CNL-18-120

Browns Ferry Nuclear Plant, Unit 1
Renewed Facility Operating License No. DPR-33
NRC Docket No. 50-259

Subject: **Response to Request for Additional Information Regarding Browns Ferry Nuclear Plant Unit 1, American Society of Mechanical Engineers Boiler and Pressure Vessel Code Section XI, Inservice Inspection (ISI) Program, Unit 1 Second Ten-year Interval Request for Relief for 1-ISI-28 (EPID L-2018-LLR-0079)**

**Response to Browns Ferry Unit 1 RAIs Related to Request for Relief for 1-ISI-28
(EPID L-2018-LLR-0079)**

Figure 2-4 from EPRI Report IR-2004-43
Browns Ferry Standby Liquid Control Nozzle (N10): Probe Scan Limits and Examination Coverage for Detection Technique 70/(2 to 23)vs at Theta = 0°

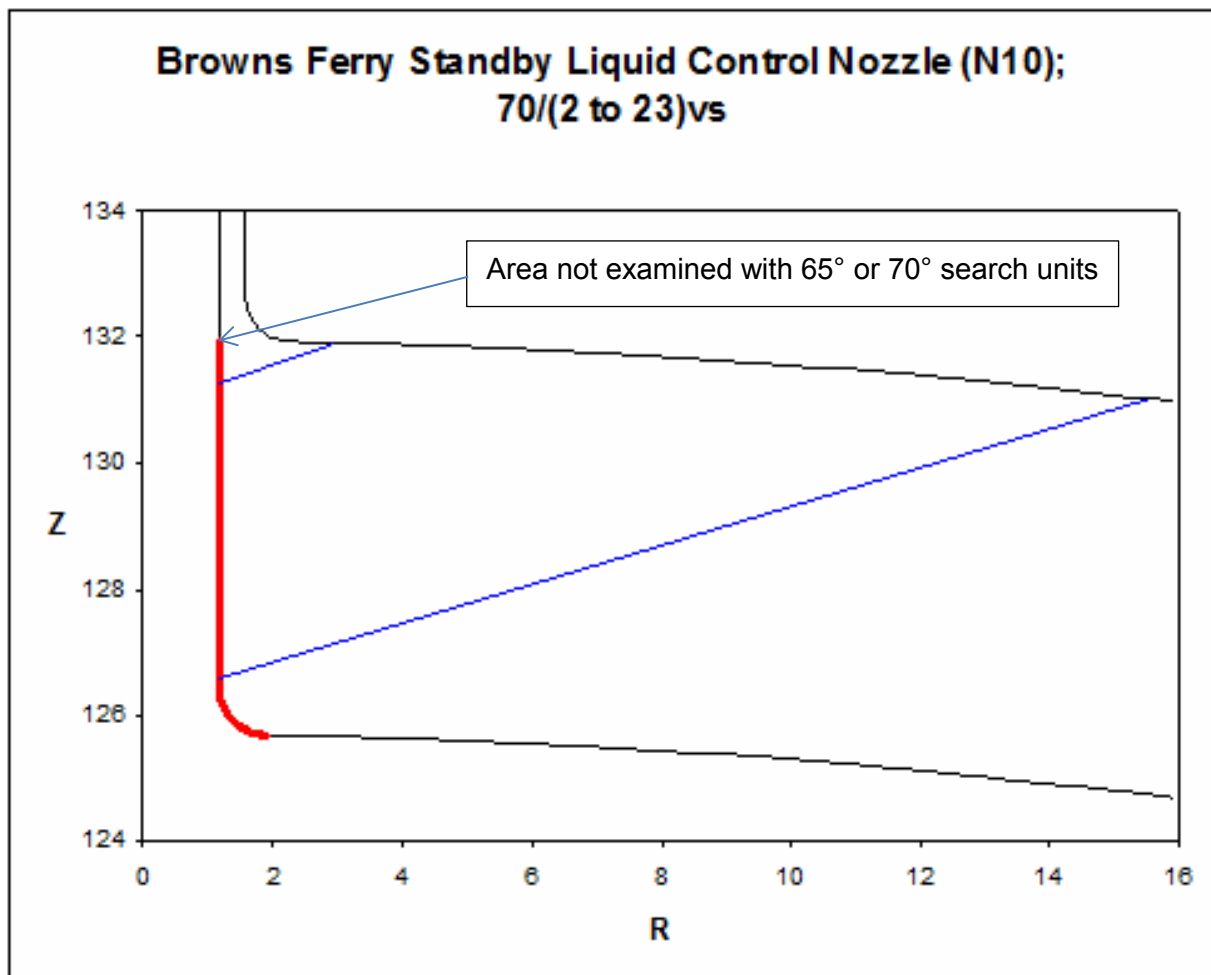
Regarding weld numbers N2D-IR (Recirc Inlet), N2E-IR (Recirc Inlet), N2G-IR (Recirc Inlet), N5A-IR (Core Spray), N5B-IR (Core Spray), N8A-IR (Jet Pump Instrumentation), and N10-IR (SLC) please provide diagrams showing the coverage that was obtained, coverage calculations and obstructions inhibiting further examination.

Figure 2-4 from EPRI Report IR-2004-43 is a depiction of the effective examination coverage realized with the 70° search unit. Beam angle is displayed in blue and the red in the diagram illustrates the examination area. The area depicted in red above the beam angle in the upper left portion of sketch is the area that is not examined by either the 65° or the 70° search units.
